Bruce L. Chrisman
Directorate

March 3, 2011

SUBJECT: NATIONAL ENVIRONMENTAL POLICY ACT (NEPA) APPROVAL FOR
THE INDUSTRIAL AREA SITE UPGRADES PROJECT

Aerial View of Proposed Upgrades to the Industrial Area

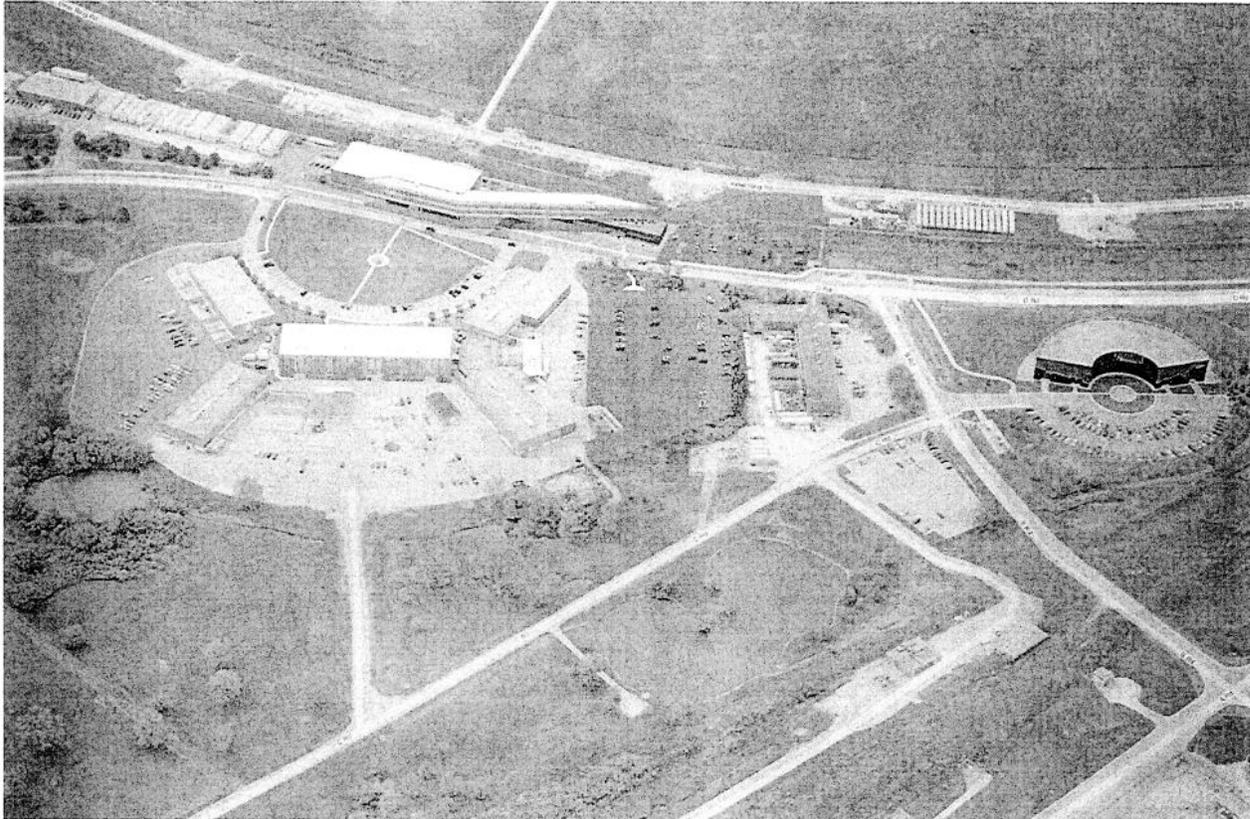
The project change would increase the proposed parking lot area to approximately 1.8 acres (previously 1.6 acres) which would increase the entire project area to approximately 2.8 acres (previously 2.6 acres) and approximately 8500 cubic yards (previously 1000 cubic yards) of clean material would be excavated, stockpiled, and reused for the regrading and parking lot portion of the work. The increase in excavated material is due to the poor soil identified through recent soil borings in the area.

This project change is proposed in order to accommodate a recently identified need for even greater parking capacity than was originally estimated for the Industrial Area as well as providing repair to the existing adjoining parking lot. Therefore, Fermilab would like to accommodate the increased parking demand by adding to the existing parking lot further to the west and provide repairs to the existing parking lot. The repair work and the additional parking area necessitate converting part of the existing maintained open drainage way by extending the existing underground storm pipe system further west. The maintained open drainage way (surface water run-off and the Fermilab Industrial Cooling Water System) is identified in a wetland delineation report by Huff & Huff (dated December 2010) as "degraded wetland."
